August 2, 2000

RE: Responses to USEPA Comments on the July 2000 Final Remedial Design Submittal
H.O.D. Landfill Site
Antioch, Illinois

Response to USEPA Region 5 Comments on the July 2000 Final (100%) Remedial Design Submittal (Construction Documents) – H.O.D. Landfill

ENVIRONMENTAL MONITORING PLAN

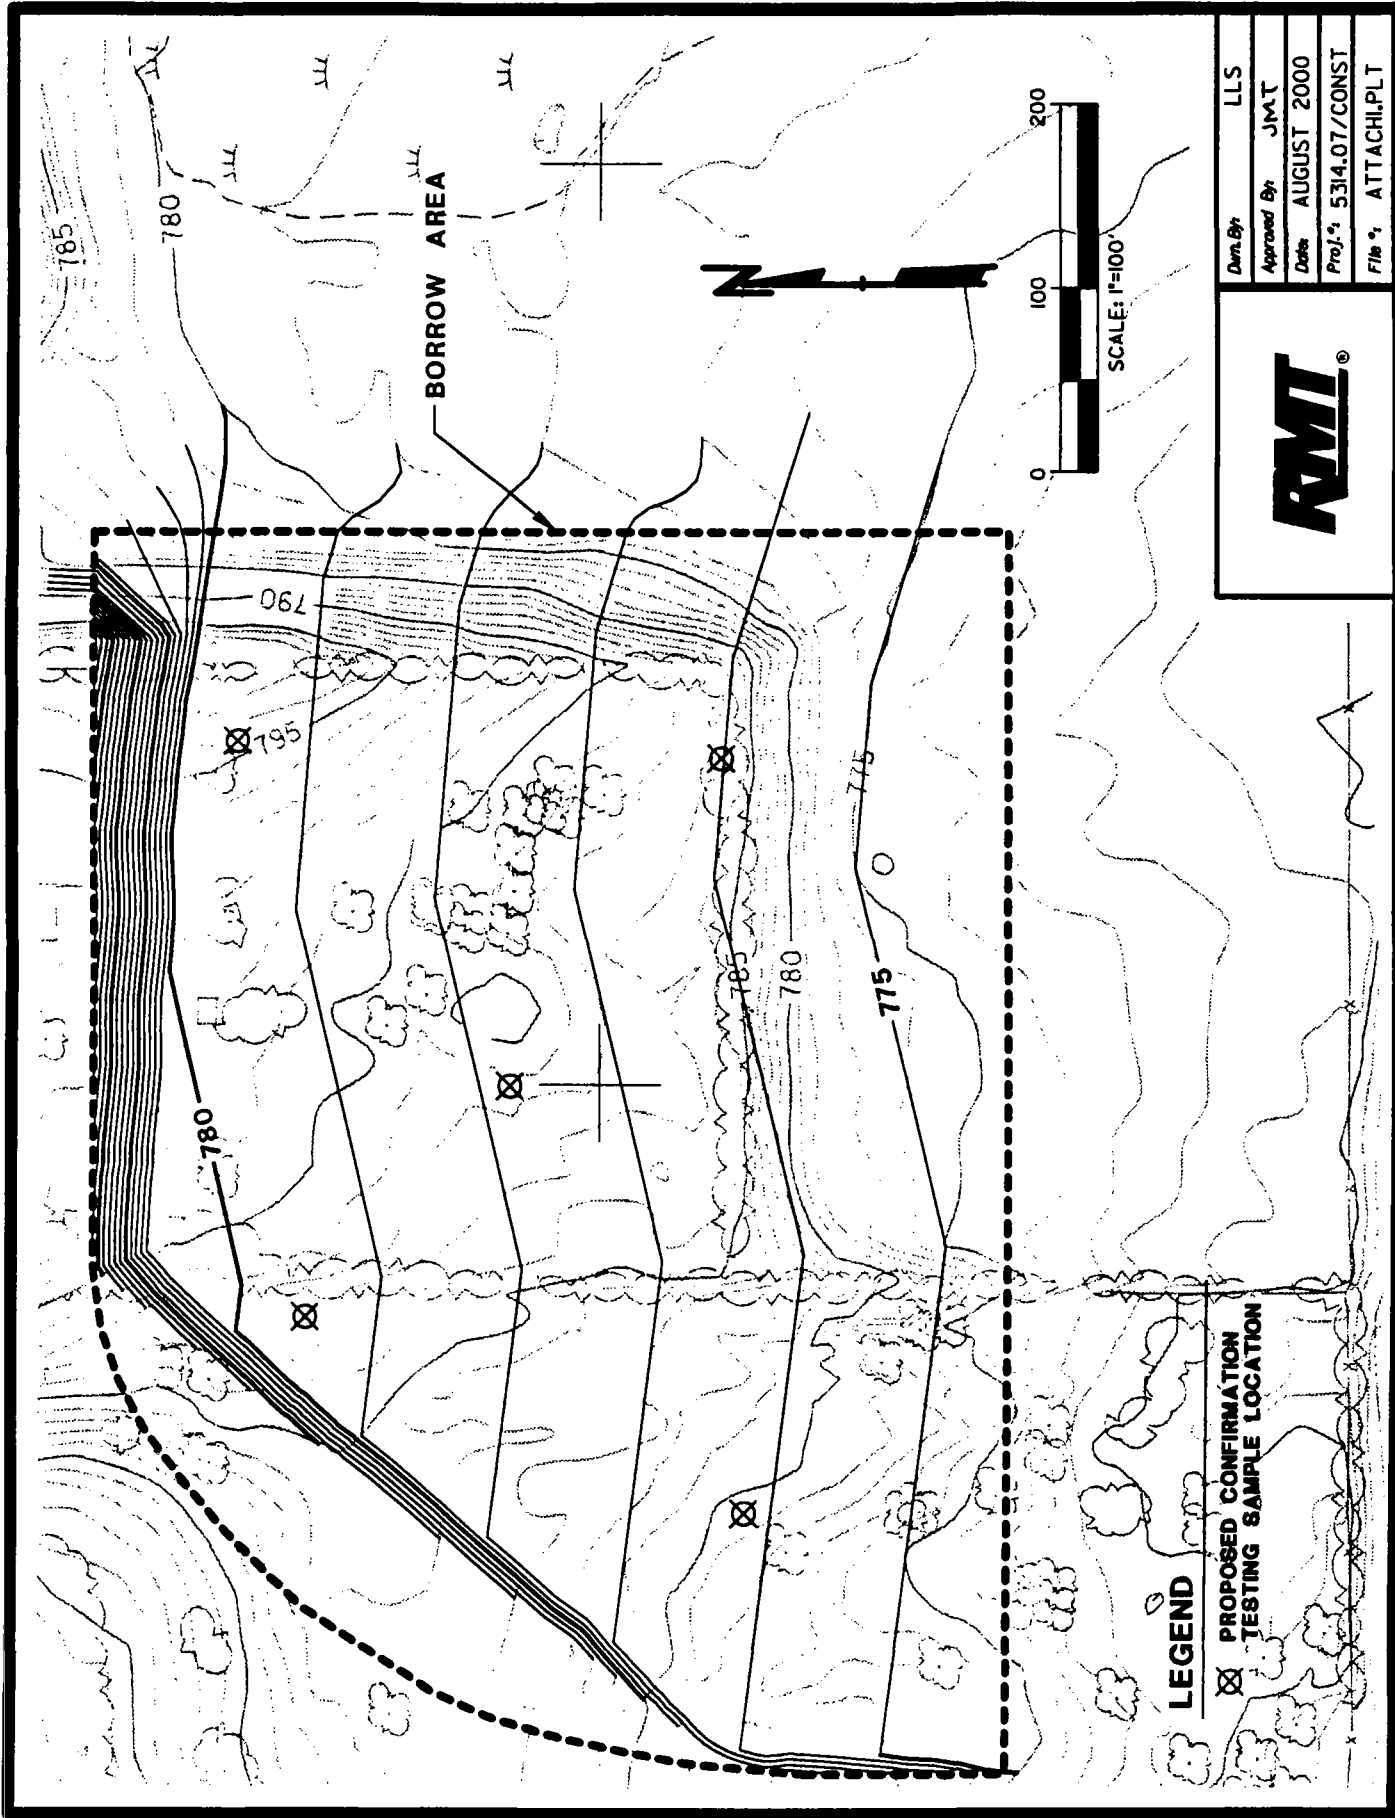
3. *Response to Comment 7, Page 7; and Comment 11, Page 12: The language regarding all well abandonment should be removed from the design and will be dealt with during the O&M. Also, the tabulation showing wells to be abandoned on Drawing 11 should be removed. The legend on Drawing 11 for wells to be abandoned should be modified for clarity.*

All references to abandonment of groundwater monitoring wells have been stricken from the RD Report, including the first four paragraphs in Subsection 3.8 of the RD Report, Table 3-1 of the RD Report, and the tabulation showing wells to be abandoned on Drawing 11. Drawing 11 has also been modified for subsequent clarity. This issue will be addressed during review of the O&M Plan and FSAP.

FIGURE 8-1

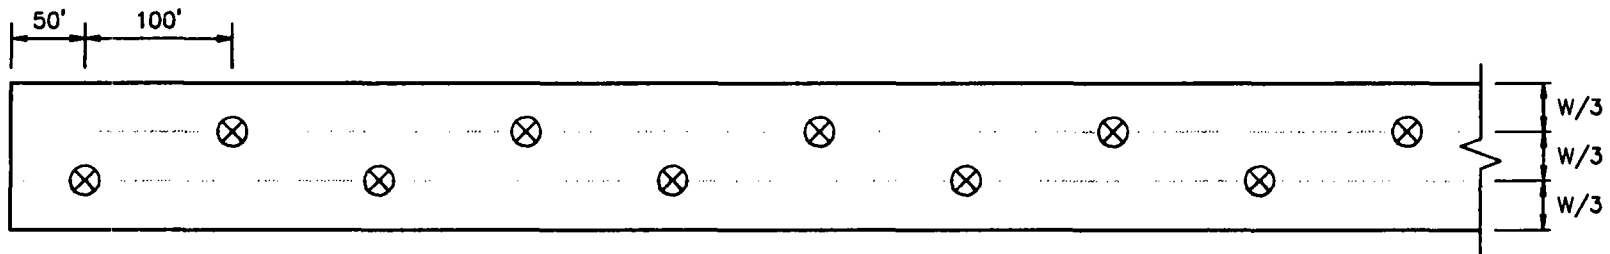
8. *Response to Comment 16, Page 27; and Attachment 7: The suggested laboratory testing for confirmatory sampling after relocation of waste is not acceptable. The laboratory sample should be collected using a grid sampling technique with a grid size of 100 feet by 100 feet.*

The sampling frequency has been modified to incorporate both field and laboratory testing of soil every 100 feet along the length of the waste excavation area. Figure 8-1 of the CQAP has been revised to indicate this change.
